Subject: Data Response, Set 2E
Hidden Hills Solar Electric Generating System (11-AFC-2)

Hidden Hills Solar Electric Generating System (HHSEGS)

**Data Response, Set 2E
(Response to Data Requests 177 through 188)**

Figure 1 above represents the spectrum of the photopic luminous efficiency function, V_λ (black), and a representative solar spectrum (Wehrli, red). The visual response (green) represents the visual systems sensitivity to the solar spectrum.

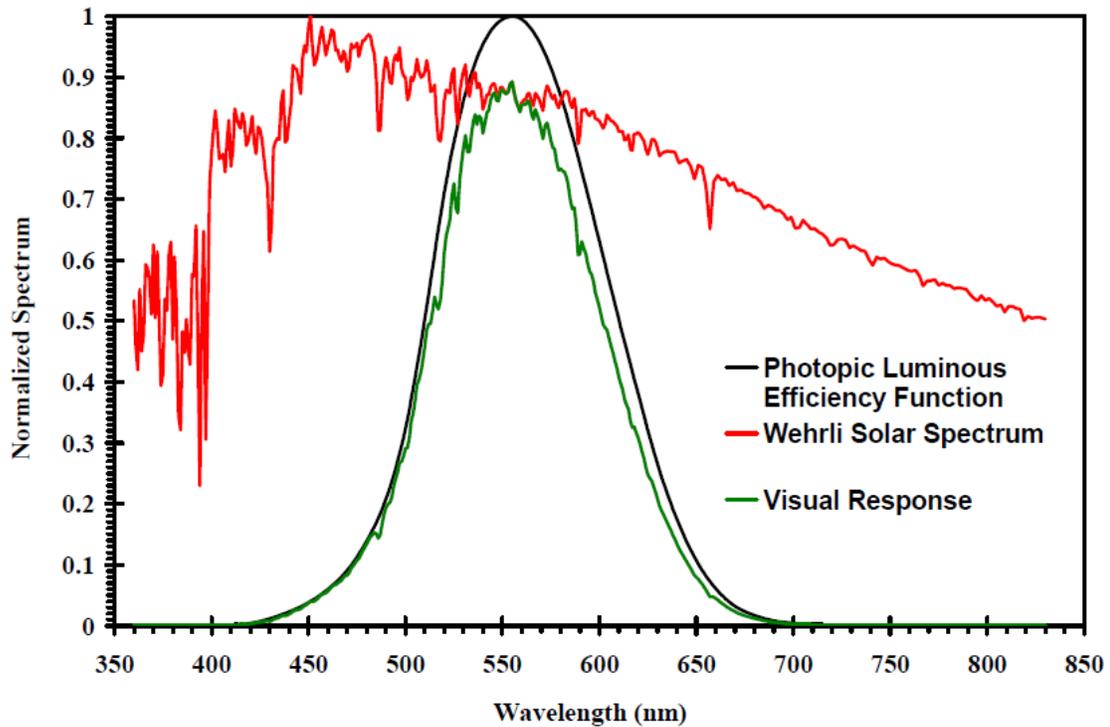
This statement is true for the consideration of physiologic damage. However, luminance is absolutely necessary for any determination of perceived brightness. The human photopic luminous efficiency function for the Standard Observer, V_λ , defines the envelope of human visual sensitivity as a function of visible wavelengths. This is shown in **Figure 1** (below) together with a representative solar spectrum (Wehrli) and the visual response/sensitivity profile to the Wehrli spectrum. It is the integrated visual response which defines luminance and contributes to perceived brightness. Staff recognizes that the relationship between luminance and brightness is not straightforward and depends on additional factors such as the observer's state of adaptation, the spatial extent of the SRSG source, and the context/background luminance. Although, as the applicant states in their response, the retinal irradiance (E_r) of the SRSG is significantly less than that of the sun, it is still on the order of approximately 30-40 times greater than that of the sky background. Staff considers this potentially significant and desires an understanding of the luminance of the SRSG during operations and its relationship to the luminance of the sky background.

186. Please provide estimates of the luminance of the SRSG during operations and the luminance of representative sky background. Please address the impact of these values and their relationship on apparent brightness, glare and visual disruption at nominal viewing distances for workers, the public and motorists.

Response: As the reflectance by the heliostat and receiver have marginal effects on the solar spectrum, the luminous efficiency is Air Mass (AM) 1.5 standard spectrum, which is calculated to be 110 lumens per watt (lm/W). Using the calculated solar flux emanating from the SRSG, as well as the solid angle subtended by the SRSG, the luminance is less than 400 kilocandela per square meter (kcd/m^2). Since the SRSG is a diffusive reflector, this value is essentially for all observers at distances farther than the nominal viewing distance.

Figure DR187-1. Luminance from Heliostats with Different Focal Lengths

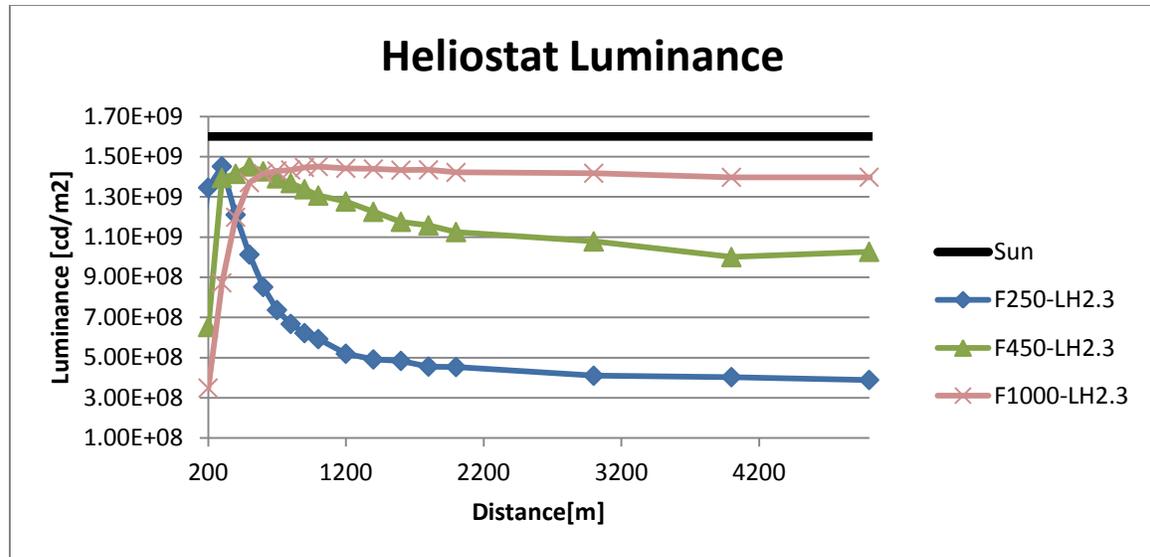
187. Please provide the analysis which leads to the applicant's quoted conclusion above. Please provide an assessment of the impact of Glint and Glare, and visual disruption to pilots when directly exposed to a heliostat solar reflection (as in a standby position) and during a succession of such exposures when flying through the field of rays produced by the population of heliostats in standby positions.

Response: The impact a single heliostat will have on a pilot outside of the control of the site (according to FAA regulations the volume that encompasses the perimeter of the site and a height to 500 feet above the towers) is similar in nature to that calculated for a single heliostat in answer to Data Request 149. It is shown there that even using conservative calculations for the relevant distances for a pilot (in excess of 1250 feet or 380 meters), the retinal irradiance is lower than the safe retinal values, and therefore, poses no glint and glare health hazard.

With respect to the visual disruption, one may see in the following plot (Figure DR187-1) the luminance from heliostats with different focal lengths for relevant distances along with the luminance of the sun ($1.6 \times 10^9 \text{cd/m}^2$). The plot is based on ray-tracing calculations of the solar flux incident onto an observation plane facing the heliostat at different distances assuming direct normal incidence of 1kW/m^2 from a sun positioned directly normal to the heliostat. To convert the solar flux to luminous flux, a luminous efficiency equal to 110 lm/W was taken based on standard Air Mass 1.5 solar spectrum and the luminance was calculated by dividing the result by the solid angle subtended by the source. The solid angle subtended by the source was calculated using ray-tracing as well, where one finds for distances of the order of the focal length of the heliostat, the solid angle is that of the entire reflective area of the heliostat; for distances much farther or closer than the focal length, the subtended angle is smaller than that of the entire area of the heliostat due to rays from the sides of the heliostat either reflecting at a too large an angle (when the observer is very far) or too small an angle (when the observer is very close) to reach the observer. For an observer just at the mirror surface, the angle subtended is that of the sun.

For all the relevant distances larger than 380 meters, the luminance from all heliostats is smaller than the luminance of the sun and therefore does not pose an excessive visual disturbance. Furthermore, typically the reflected flux is expected to be even smaller due to lower mirror reflectance, cosine effect and attenuation of the reflected radiation by the air, and which will further decrease the apparent luminance of the heliostat. Note that since most of the surrounding heliostats will be reflecting the sky back to an observer flying overhead, the relevant background luminance is that of the desert sky, making no greater contrast than that of the sun with the sky background.
